## Product Change Notification

### Bourns® Model CM322522 and PM1210 Series Chip Inductors

#### *Package Reel Cover Tape Appearance Change*

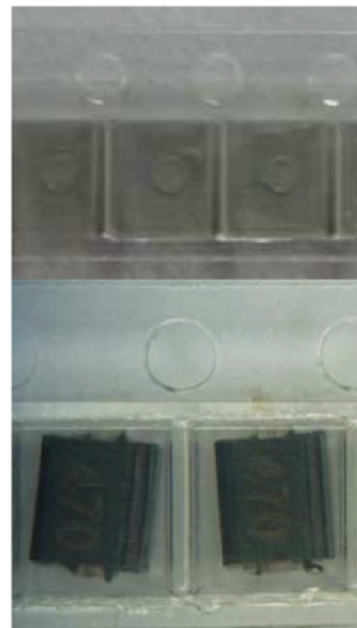
Effective immediately, the Bourns® Model [CM322522](#) and [PM1210](#) series chip inductors' package reel cover tape appearance has changed from transparent to a light gray color. This action is due to the sudden obsolescence of the former color material by the manufacturer. The cover tape material remains unchanged. The affected part numbers are listed in Table 1.

**Current Package Reel Cover Tape**  
**Transparent**

**Revised Package Reel Cover Tape**  
**Light Gray**
